DATE: December 16, 2019

SUBJECT: ADDENDUM #4 TO THE BIDDING DOCUMENTS FOR:  
**BID GROUP #8**  
**MASTER FACILITY PLAN IMPLEMENTATION**  
**COMMUNITY HIGH SCHOOL DISTRICT 99**  
**1436 NORFOLK STREET**  
**DOWNERS GROVE, IL 60516**

This addendum forms a part of the Bidding Contract Documents, dated November 20, 2019. Bidders must acknowledge receipt of this Addendum in the space provided on the Bid Form. Drawing revisions clouded and tagged throughout with delta 41.

1 AREA F - LEVEL 3 BALCONY FRAMING PLAN - ENLARGED  
SCALE: 1/4" = 1'-0"

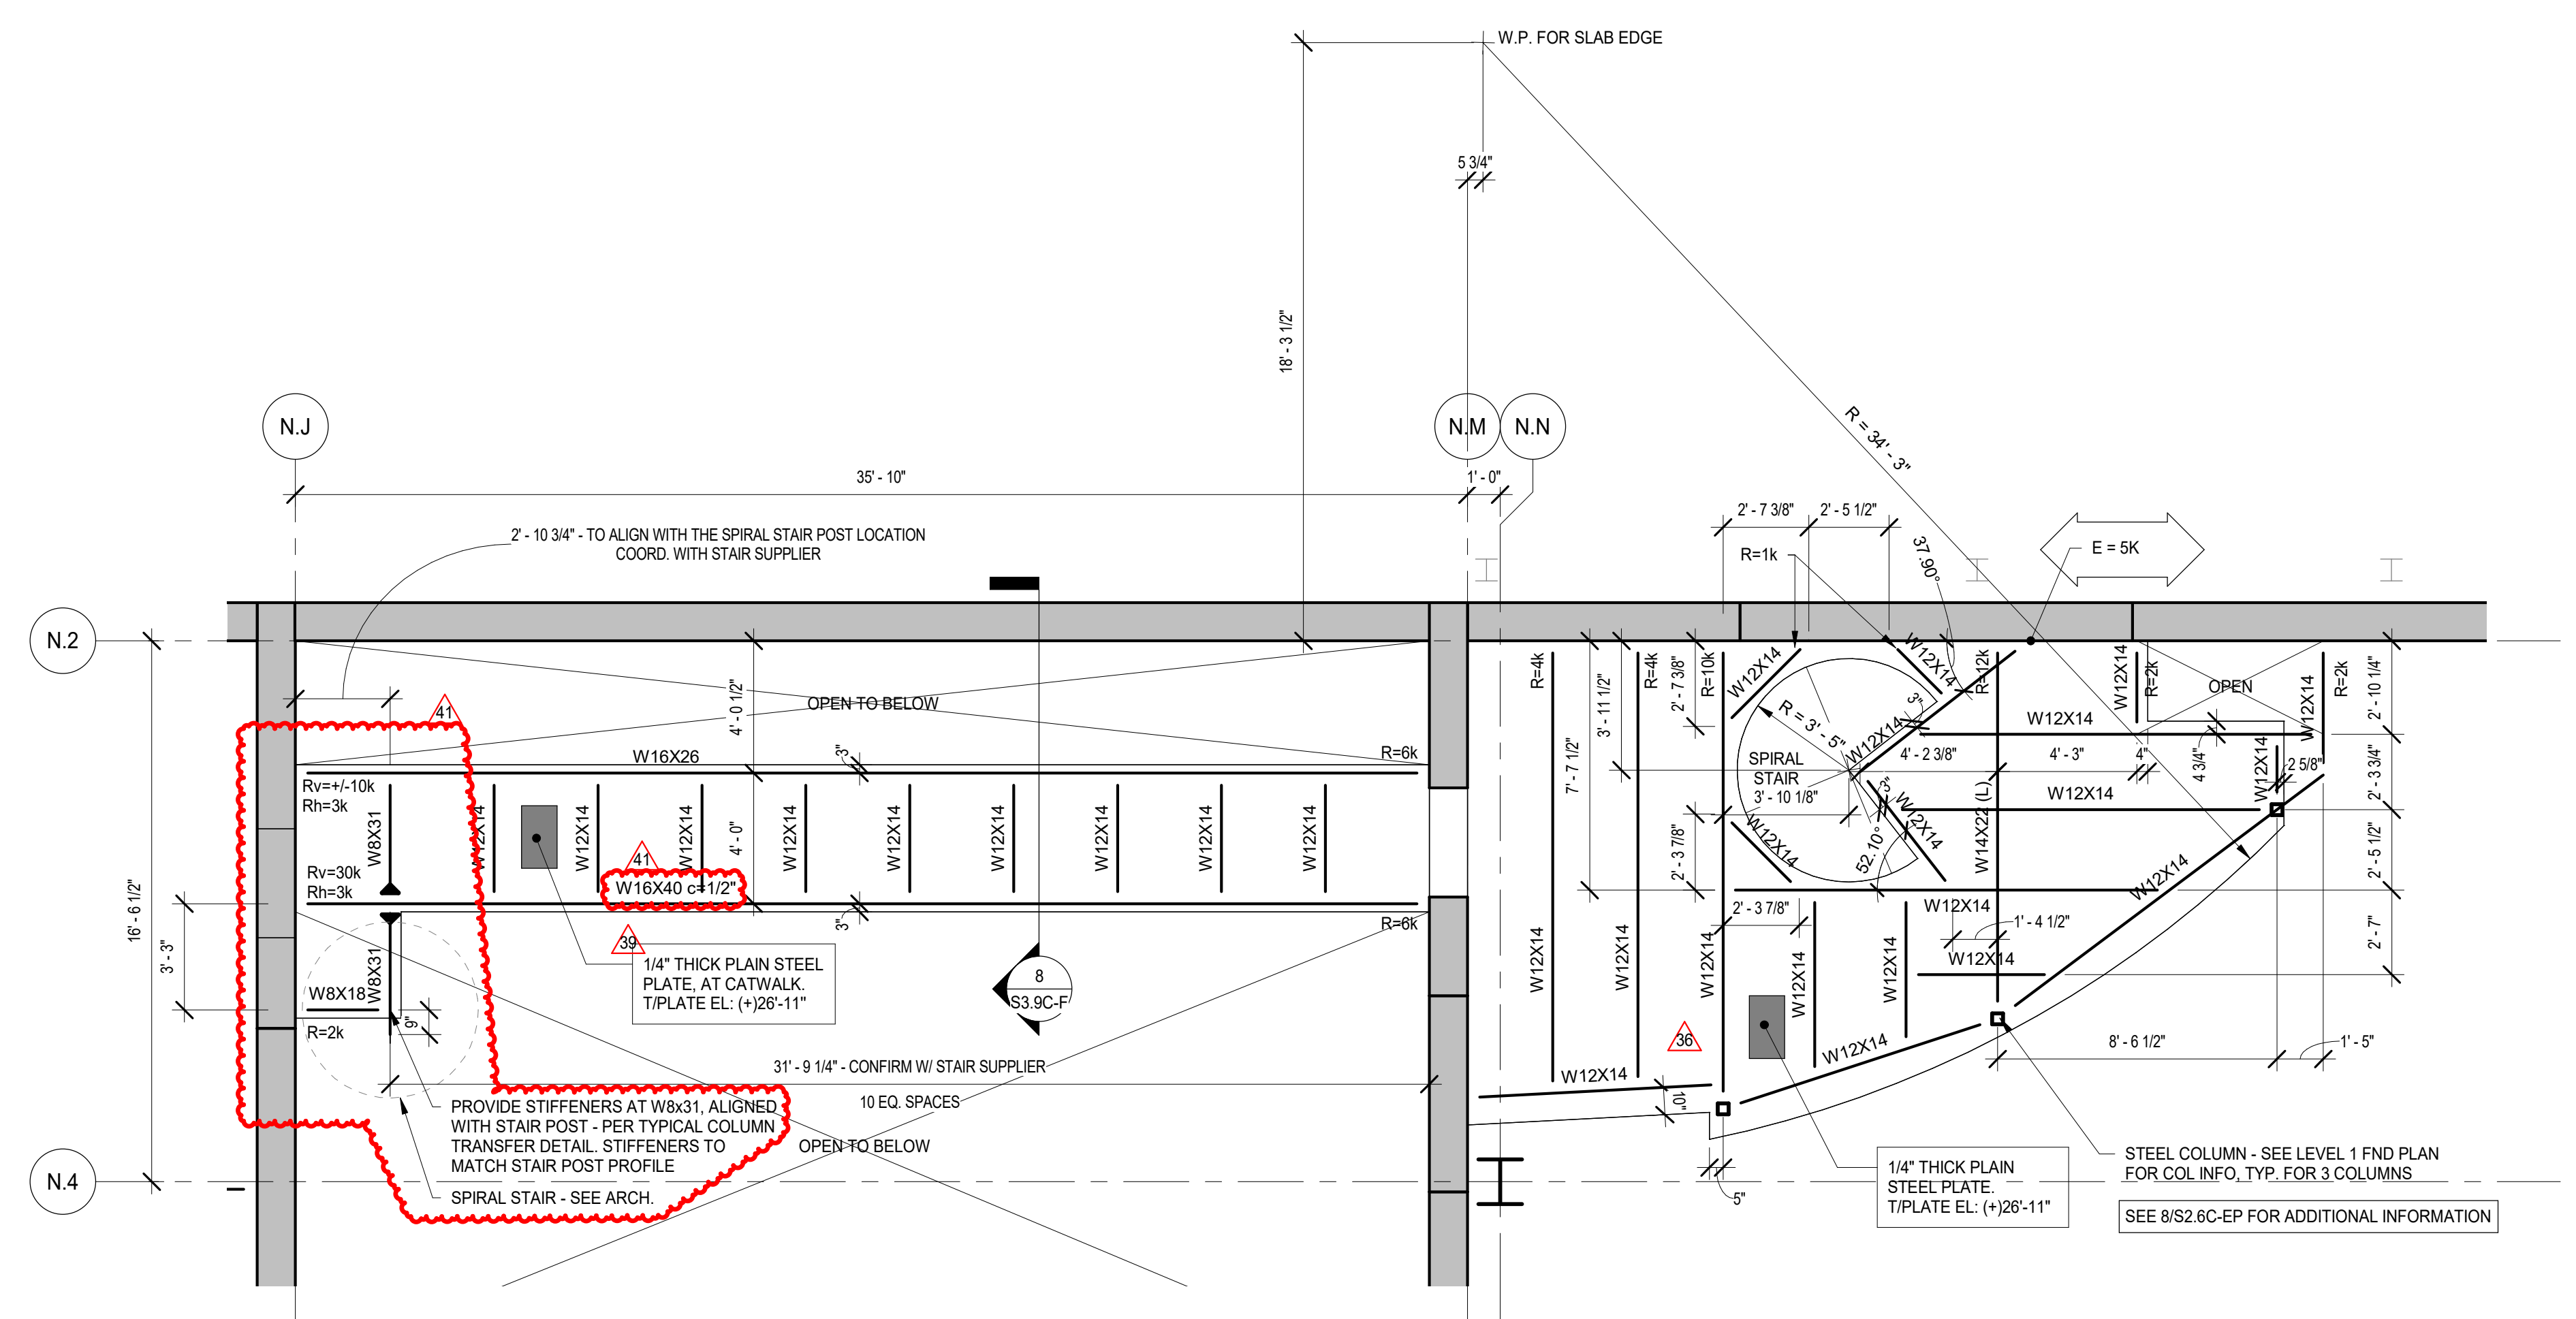
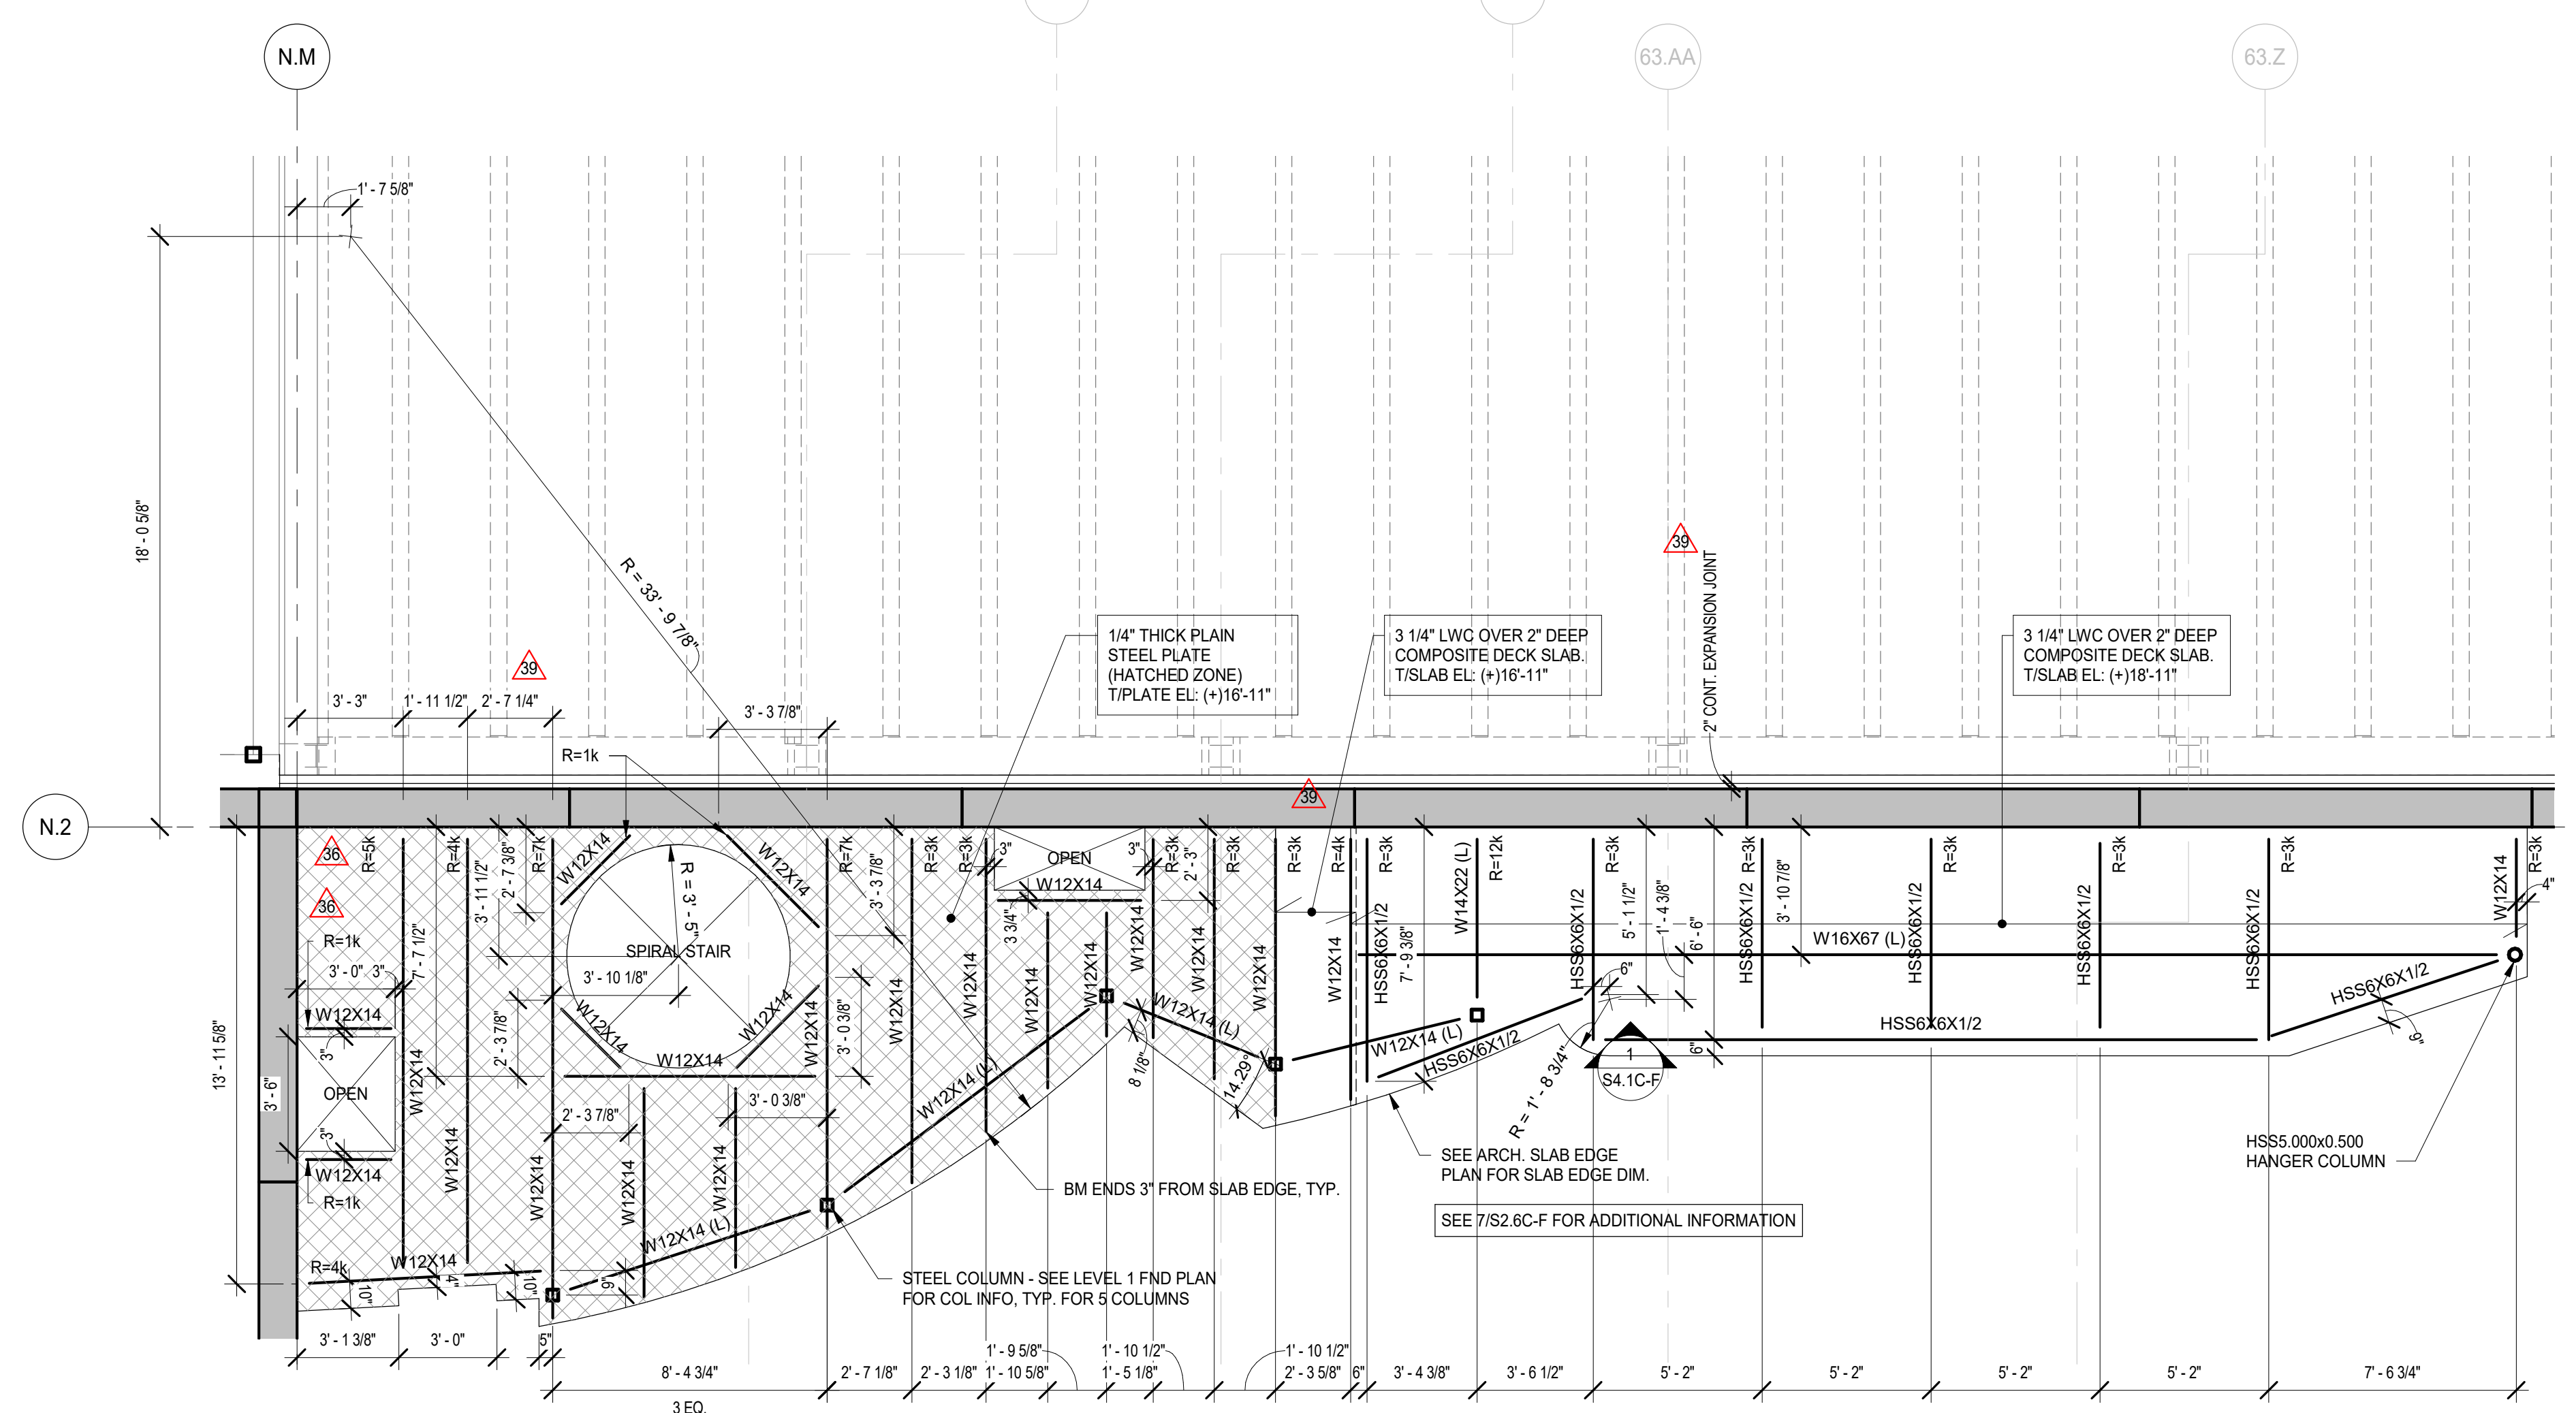
- b. Plan 2: Relocated the roof hatch opening.
10. Sheet S2.6C-F ENLARGED PLANS (**Full size sheet issued**)
  - a. Plan 7: Added steel support for the spiral stair and revised existing beam end reactions at precast wall accordingly.
